**MCB 5.0 & earlier Control Board  
(Board you are replacing)**

**TCB 6.0 or 6.1 Control Board (New Board)**

**Turnstile Control Board  
Model TCB 6.0/6.1**

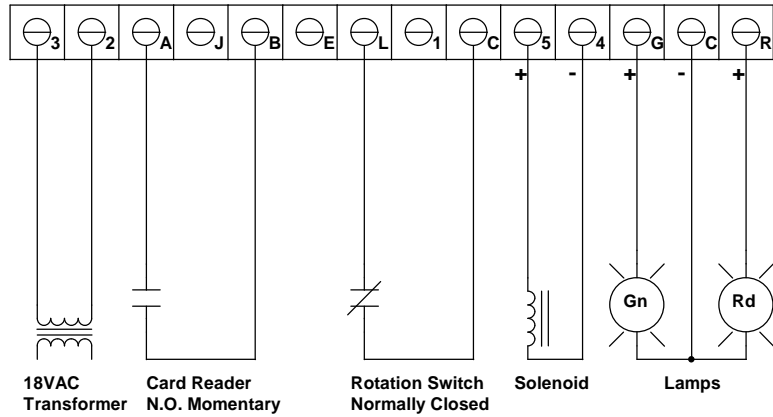
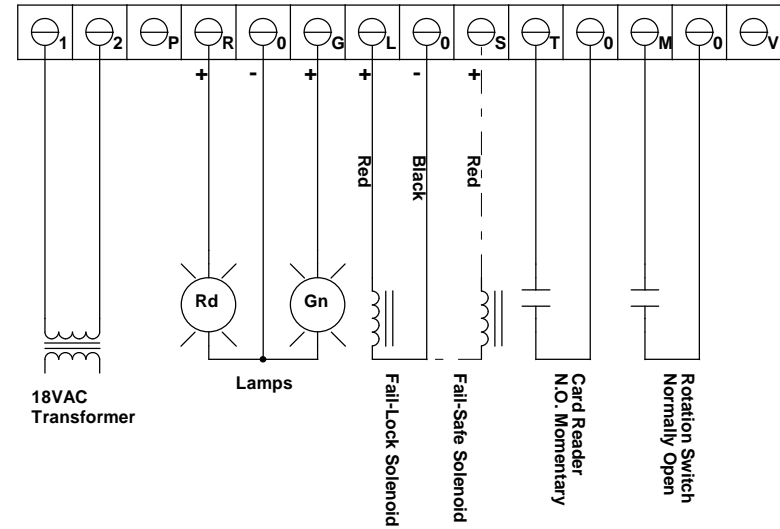
MCB 5.0 can be identified with the terminal markings shown above. Earlier versions of this board will be somewhat similar and may have a different terminal layout. In most cases this circuit board will have option connectors J11 & J21 for daughter boards/piggyback boards. In addition there may be configuration jumpers JP1, JP2 and JP3, depending on version.

This older/obsolete design required the rotation microswitch to be "Normally Closed"

This upgraded Turnstile Control Board has the same mounting footprint as earlier versions. There are no daughter boards nor configuration jumpers. Both "Pulse" and "Timer" features are standard.

Mode configuration is done by wiring the solenoid to the appropriate terminals. For Fail-Lock operation, connect the solenoid to terminals L & 0. For Fail-Safe operation, connect the solenoid to terminals S & 0.

This improved design requires the rotation microswitch to be "Normally Open" You must move the wire currently on the NC terminals of the microswitch to the NO terminals of the microswitch.

Please note the the above wiring diagram indicates terminal polarity. If you are using LED lamps then be sure to observe proper polarity. If you are using polarity sensitive solenoids (usually indicated by red & black wires), also be aware of polarity wiring. Non-polarized solenoids generally have the same color wires. Terminal 0 is always negative.

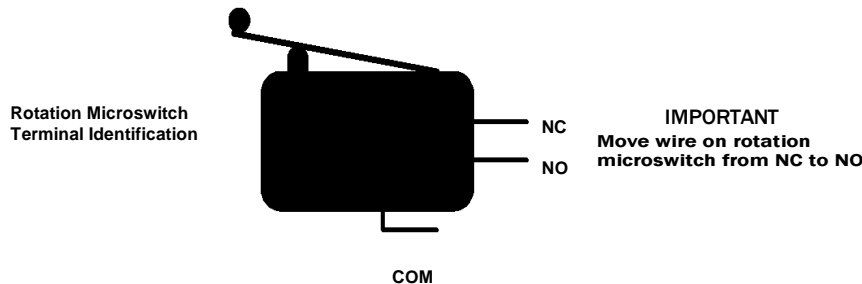
MCB 3 Thru 5.0	TCB 6.0 – 6.1
18 VAC	3 & 2	1 & 2
Red Lamp	R & C	R & 0
Green Lamp	G & C	G & 0
Card Reader	A & B	T & 0
Rotation Sw.	L & C	M & 0
FL Solenoid	5 & 4	L & 0
FS Solenoid	5 & 4	S & 0
